DART AEROSPACE LTD		Work Order: 156312
Description: Head Rest		Part Number: D3303-3
Inspection Dwg: D3303	Rev: B	Page 1 of 1

DESIGN <i>[Signature]</i>	DRAWN BY <i>[Signature]</i>	DART AEROSPACE LTD HAWKESBURY, ONTARIO, CANADA	
CHECKED <i>PH</i>	APPROVED <i>[Signature]</i>	DRAWING NO. D3303	REV. B SHEET 1 OF 4
DATE 06.08.17		TITLE HEAD REST	SCALE 1:3
REV A	DATE 04.08.18	DESCRIPTION NEW ISSUE	
B	06.08.17	UPDATED FLAT PATTERN TO FORM PART IN ONE OPERATION USING OFFSET DIE

DRAWING NO. D3303	TITLE HEAD REST	REV. B	DART AEROSPACE LTD ENGINEERING ORDER		D.E.O. NO. D3303-B-1	SHEET NO. SHEET 1 OF 1	SCALE NTS
DRAWN AJS	CHECKED <i>h</i>	MFG. APPR. <i>h</i>	APPROVED <i>h</i>		DE APPR. <i>h</i>		
DATE 08.10.15	DATE <i>08.10.15</i>	DATE <i>08/10/16</i>	DATE <i>08/10/16</i>		DATE <i>08/10/16</i>

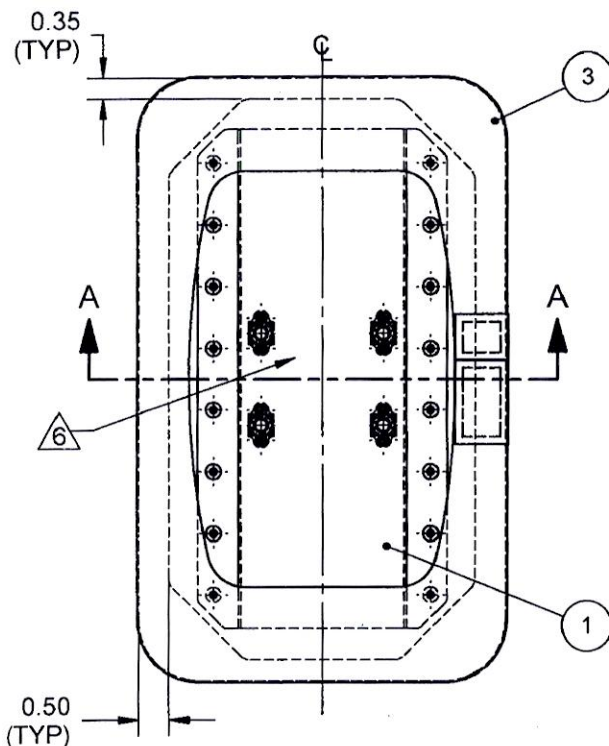
SHEET 1 ADD 1300L ADHESIVE BY 3M TO NOTE 1 AS FOLLOWS:

WAS:

NOTES:

- 1) BOND D3305-1 FOAM TO D3303-043 BRACKET ASSEMBLY USING 3M 1300 ADHESIVE (0.002" TO 0.010" THICK) IN ACCORDANCE WITH MANUFACTURER'S INSTRUCTIONS

IS:

NOTES:

- 1) BOND D3305-1 FOAM TO D3303-043 BRACKET ASSEMBLY USING 3M 1300 OR 1300L ADHESIVE (0.002" TO 0.010" THICK) IN ACCORDANCE WITH MANUFACTURER'S INSTRUCTIONS
